Addendum No. 1

RE: Contract # C204553

Pender County (R-3300B)

NC-417 (HAMPSTEAD BYPASS) FROM SOUTH OF NC-210 TO NORTH OF SR-1563 (SLOOP POINT LOOP RD)

PROJECT REFERENCE NO. R-3300B	SHEET NO. 23
RW SHEET NO.	HYDRAULICS ENGINEER
ROADWAY DESIGN ENGINEER	SEAL 025513 MICHAEL D. LINDSEY
	SEAL 26971 JOSHUA G. DALTON

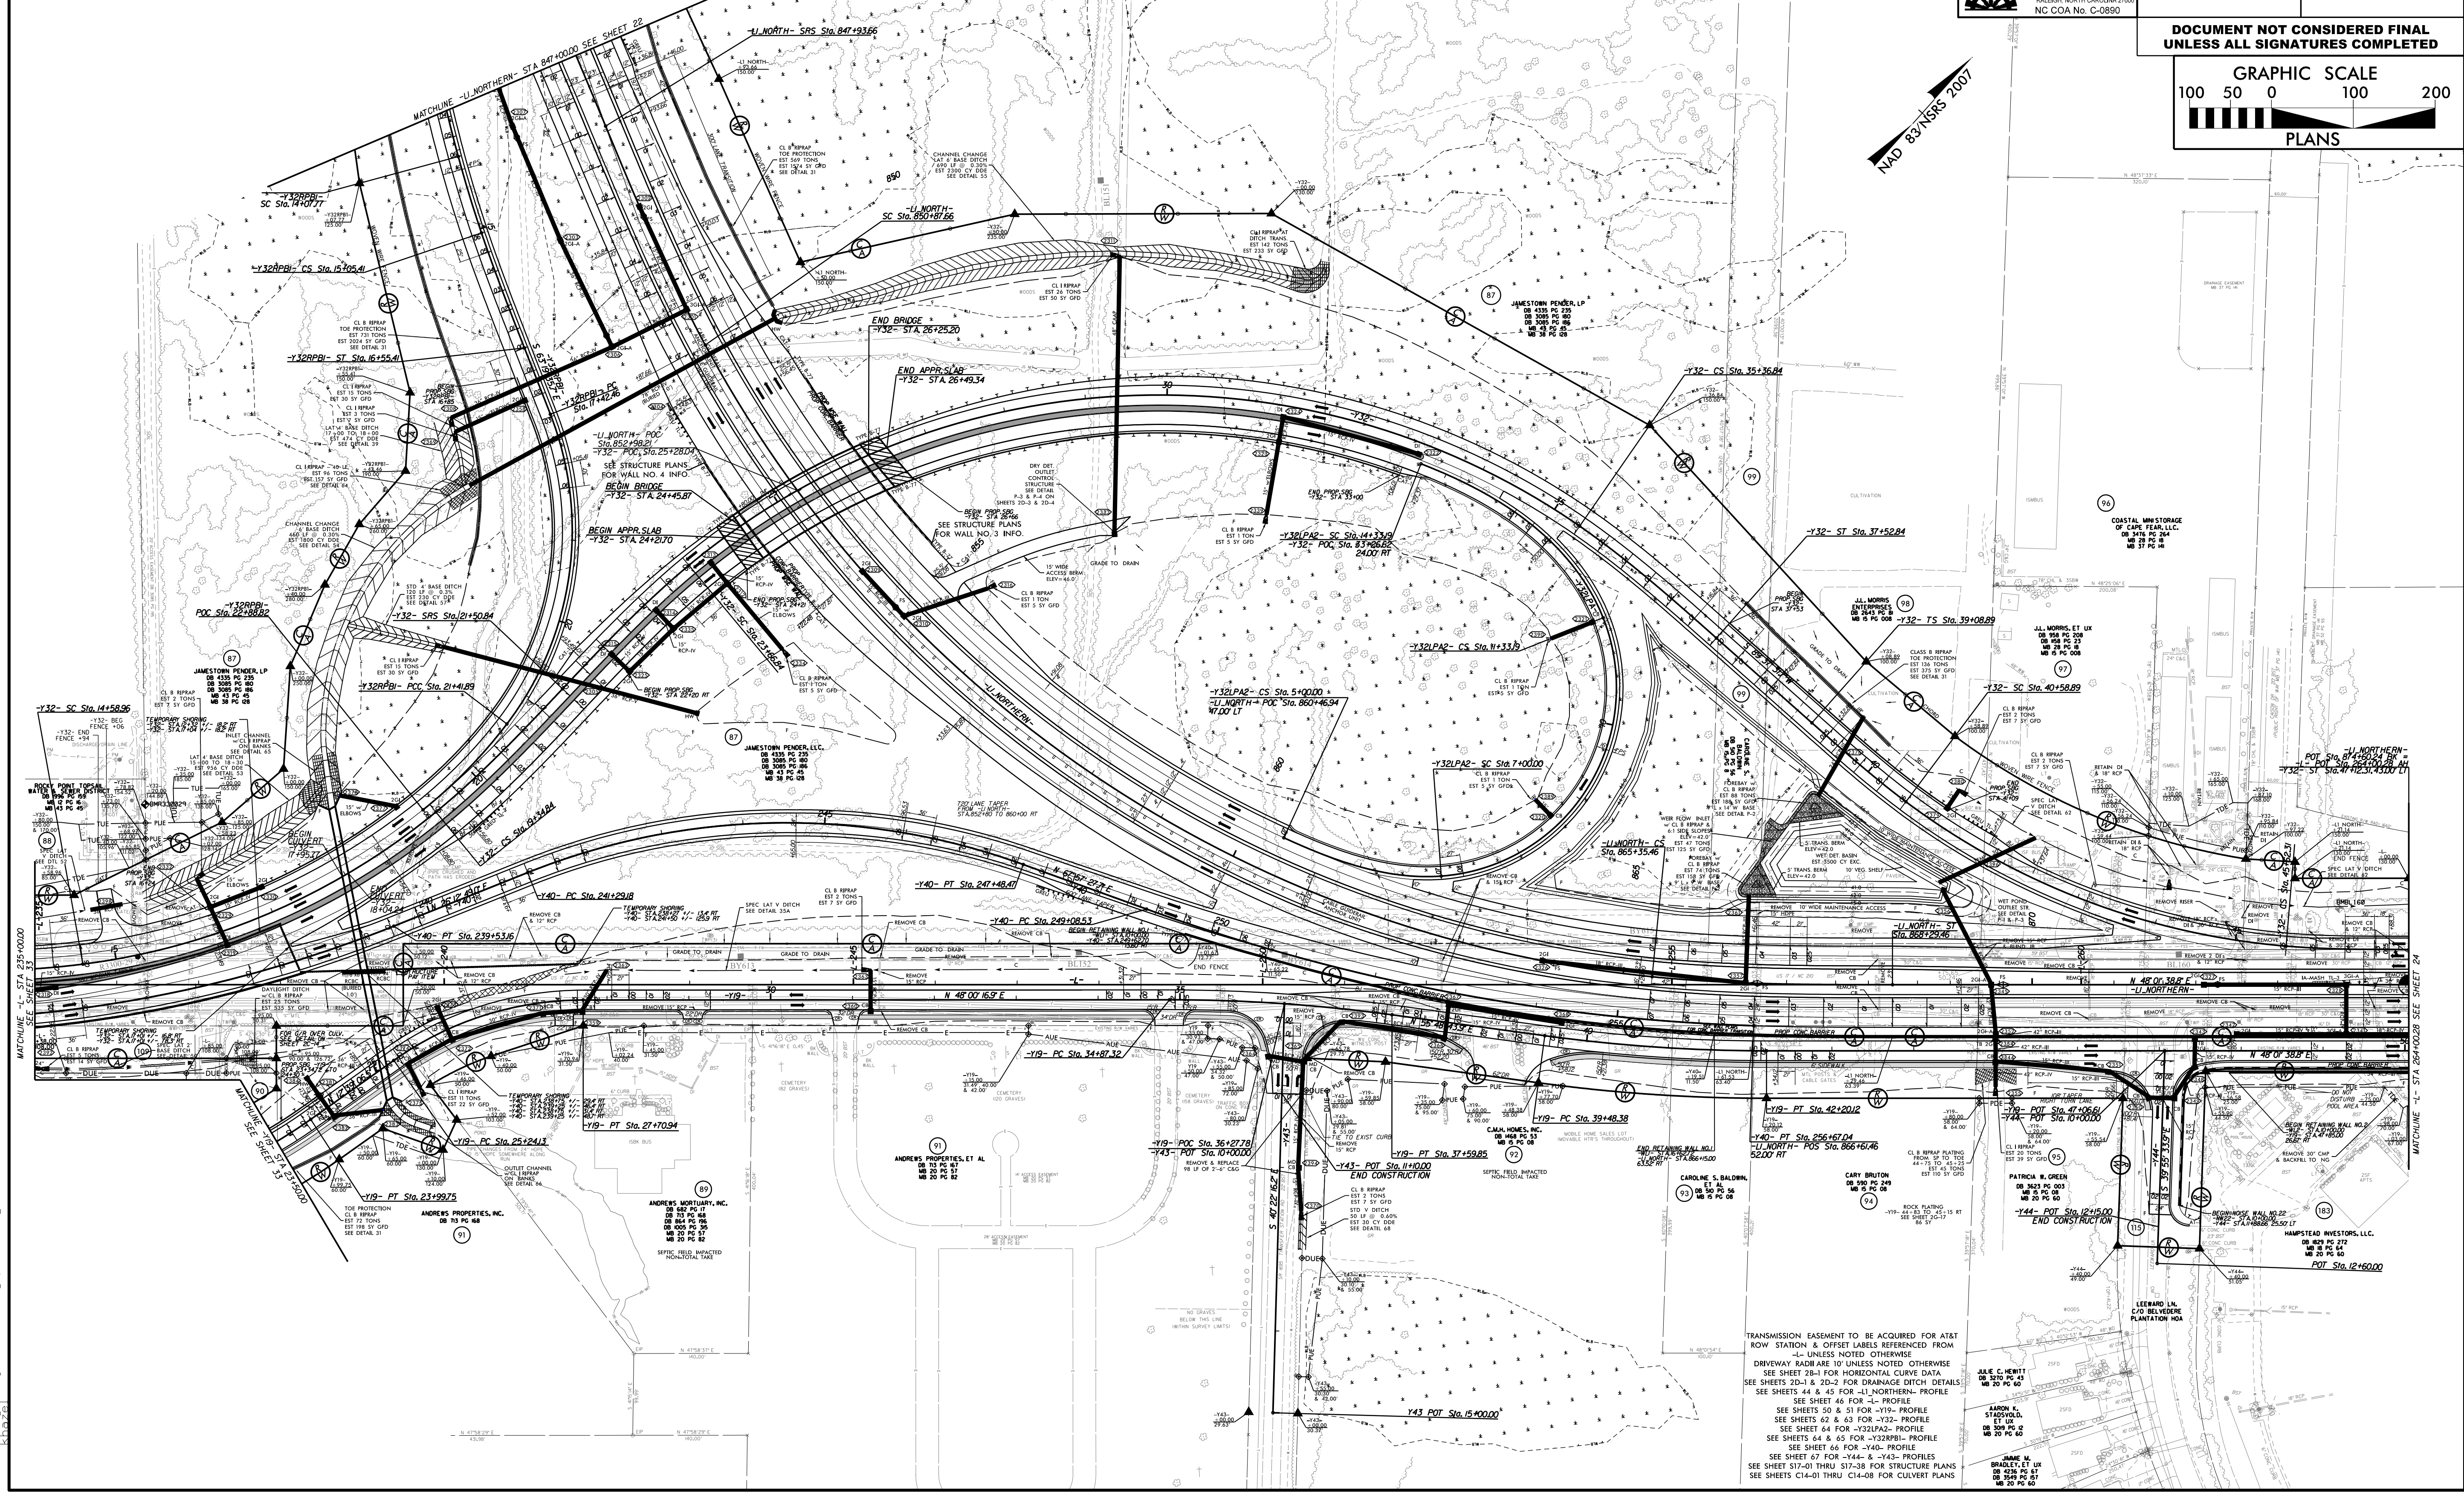
Sheet No.	Revision
23	Right of Way information modified.
33	Right of Way information modified.

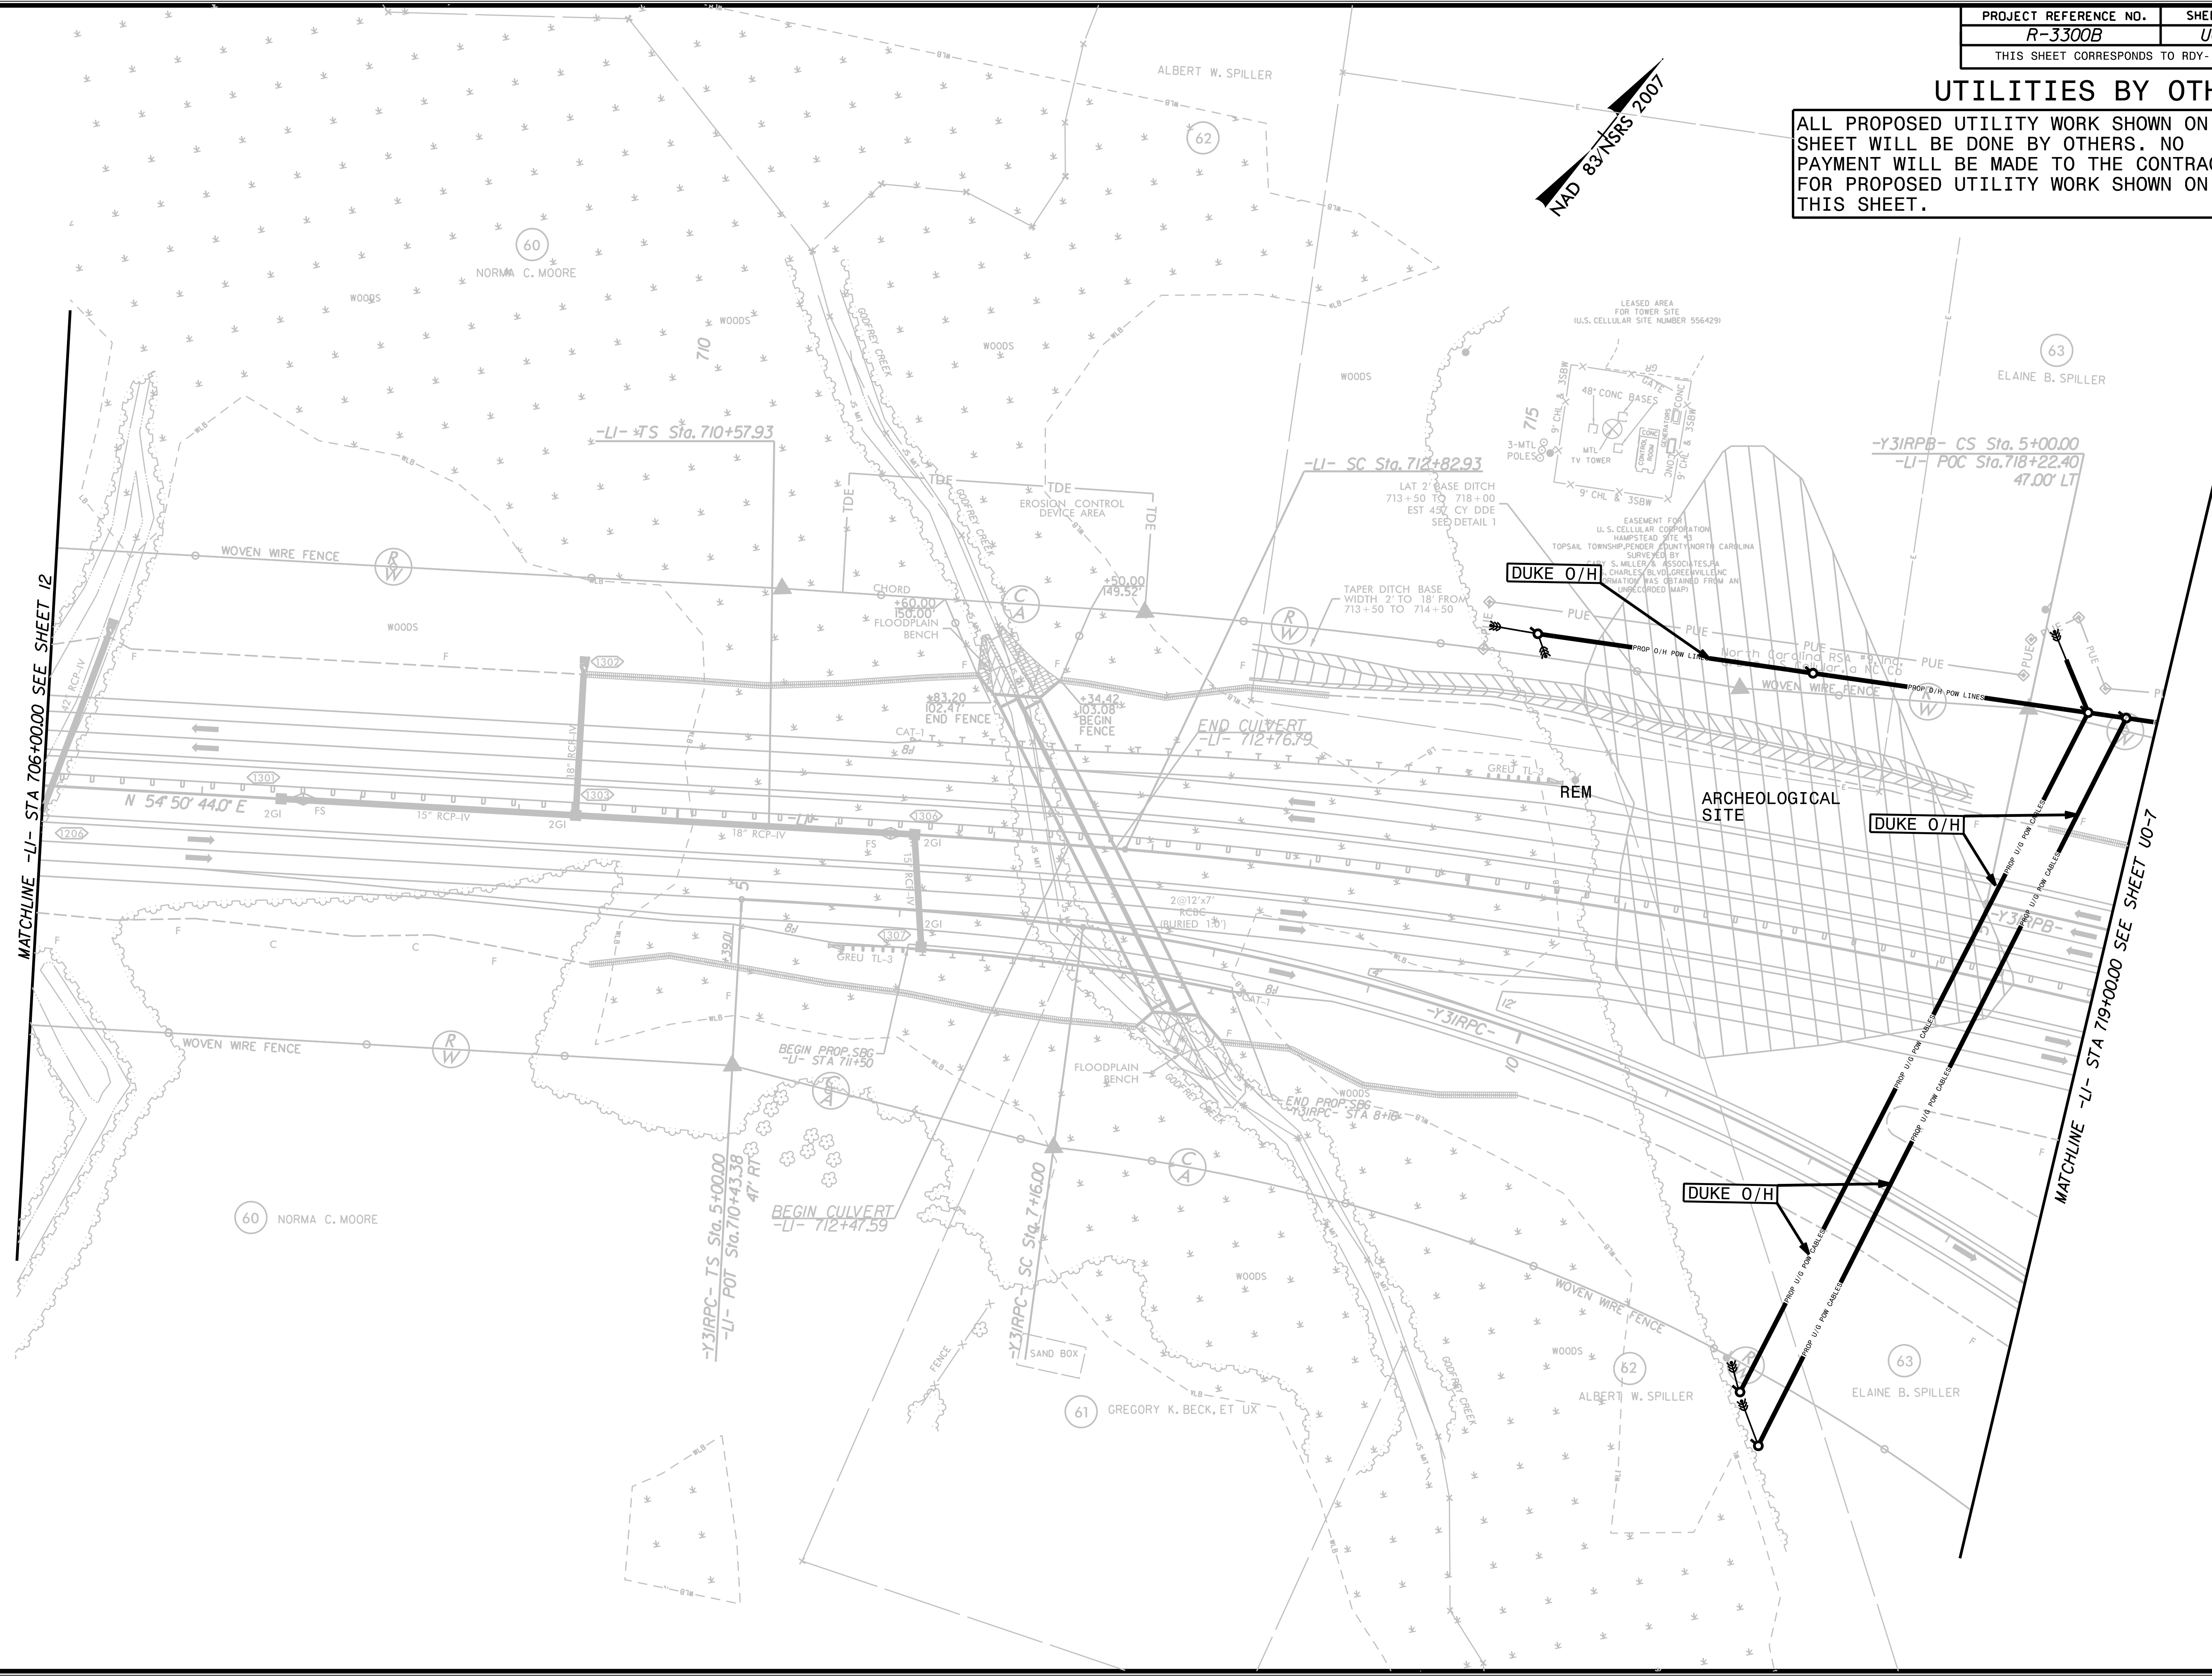
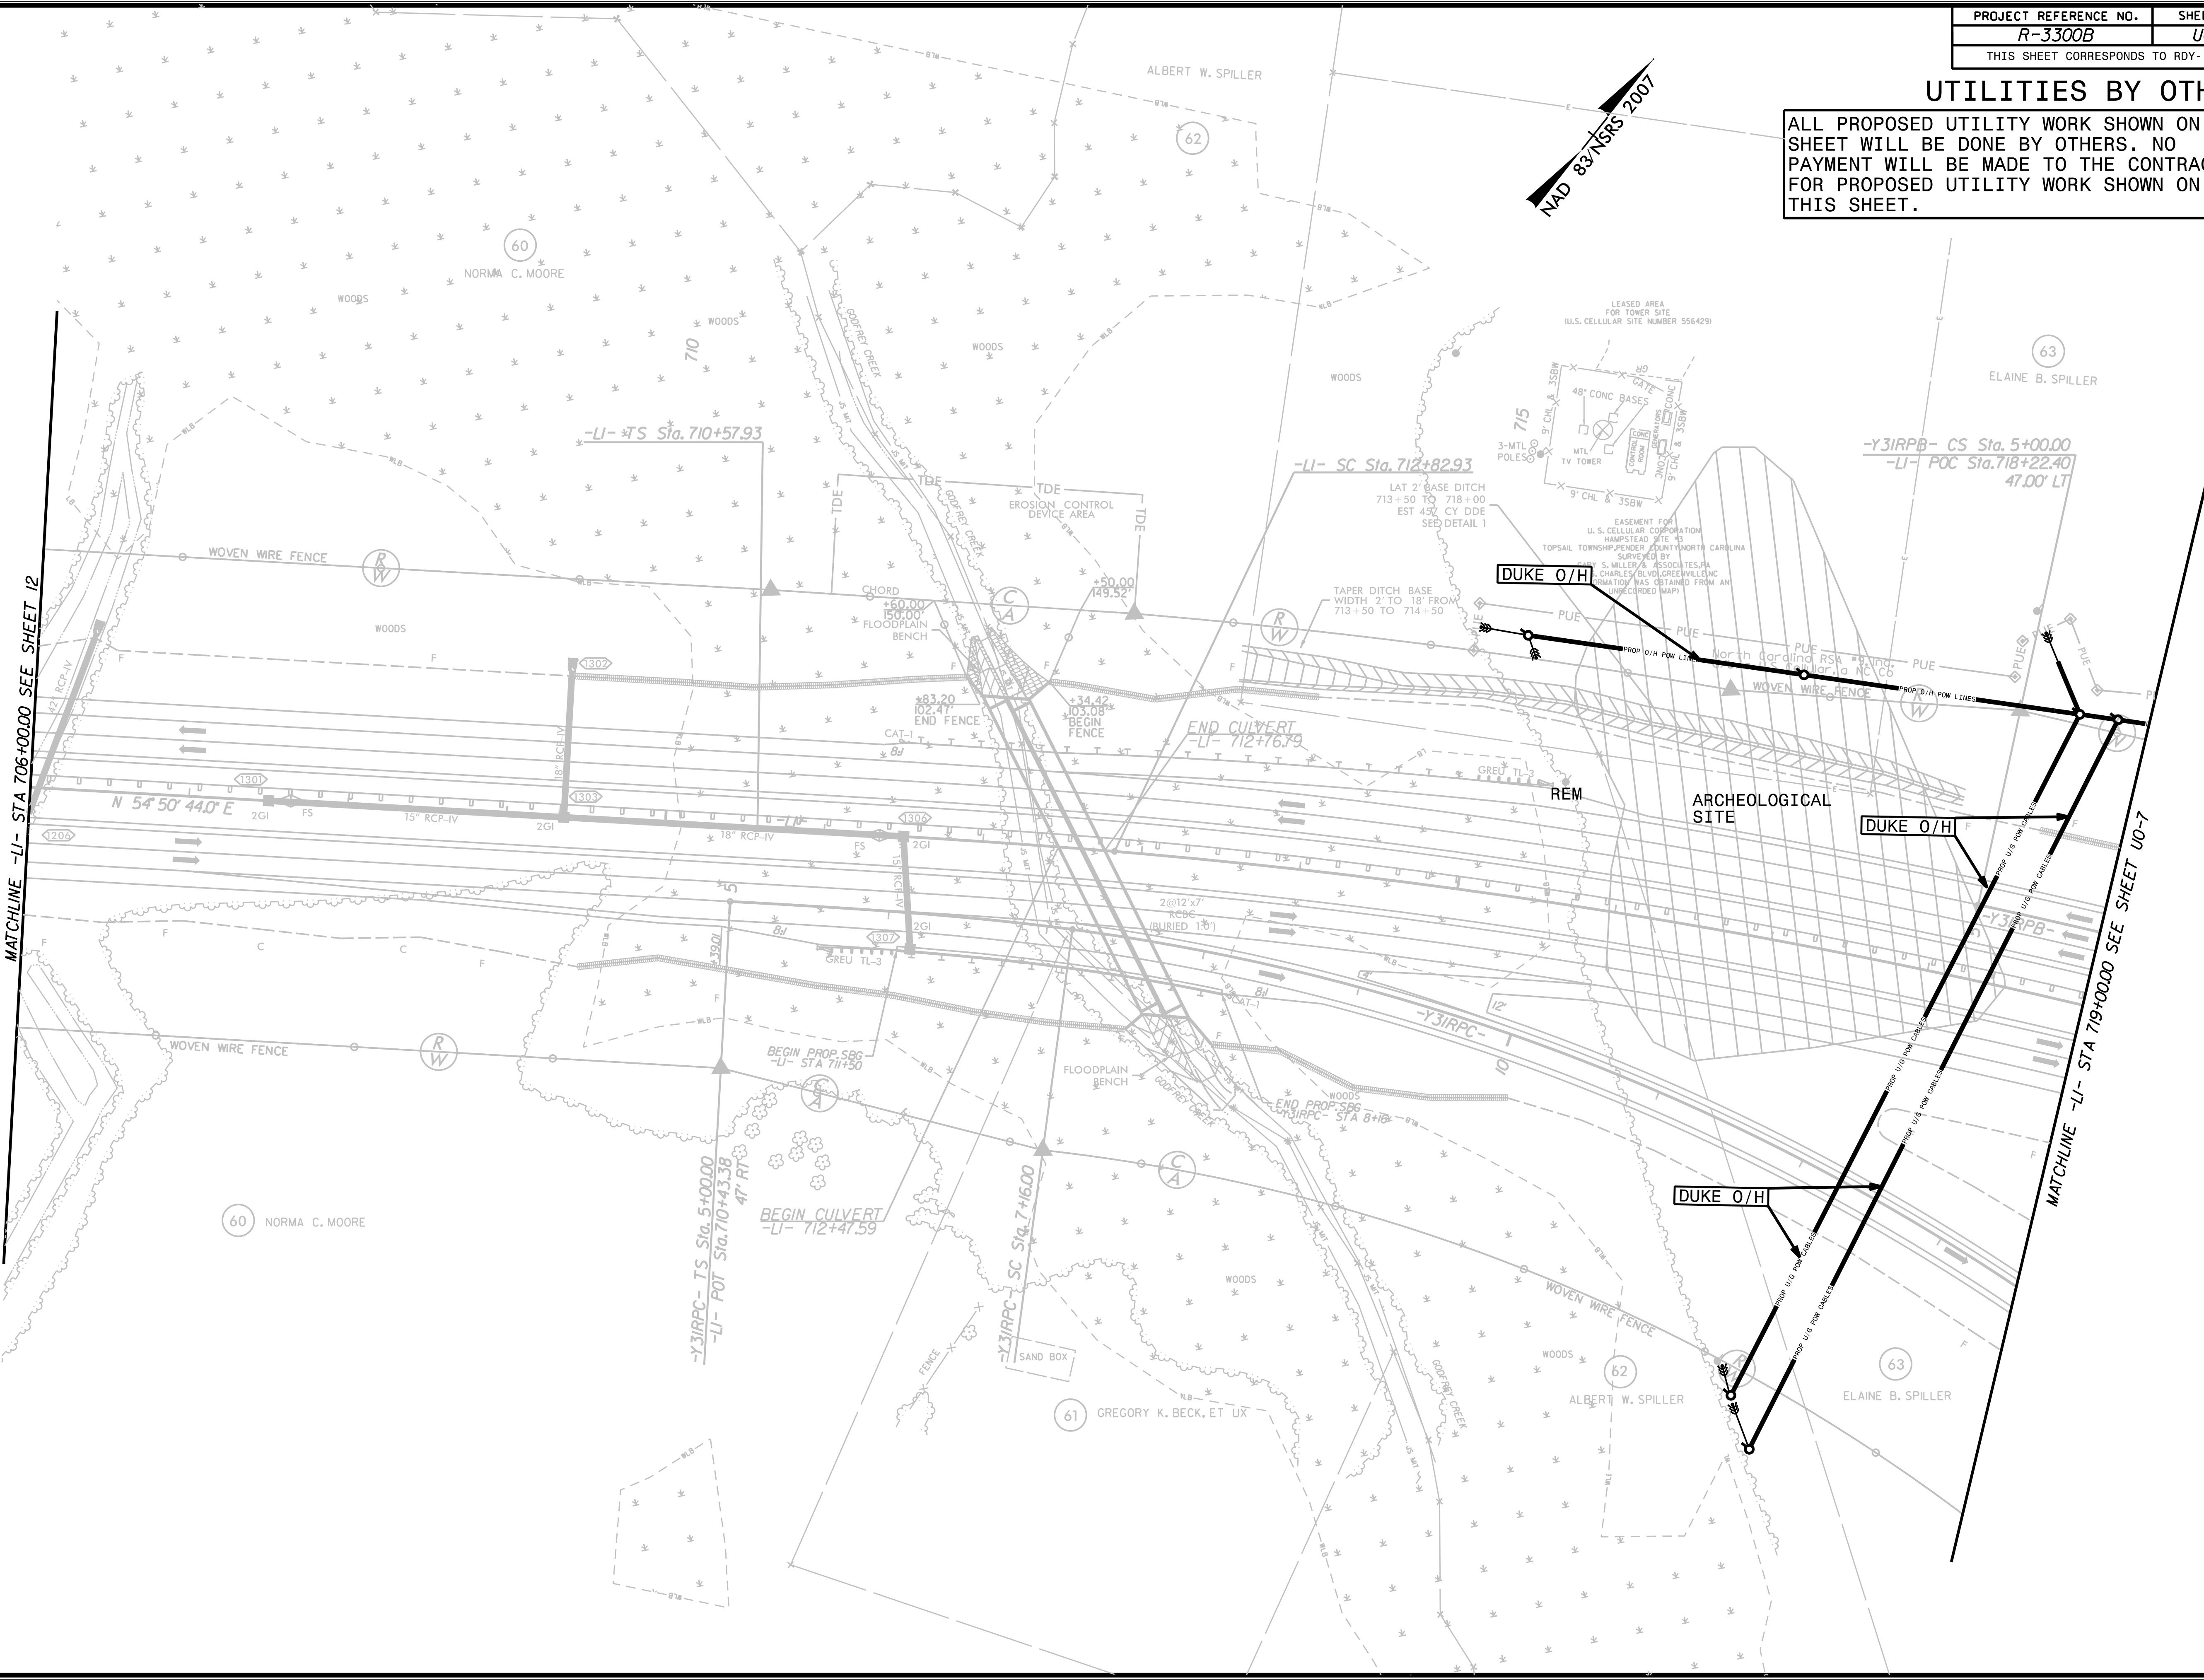
Sheet No.	Revision
UO-5	Removed Abandoned note.
UO-6	Duke U/G revised to Duke O/H. Spectrum U/G revised to Duke O/H.
UO-7	Duke/Spectrum O/H revised to Duke O/H. Spectrum U/G line removed.
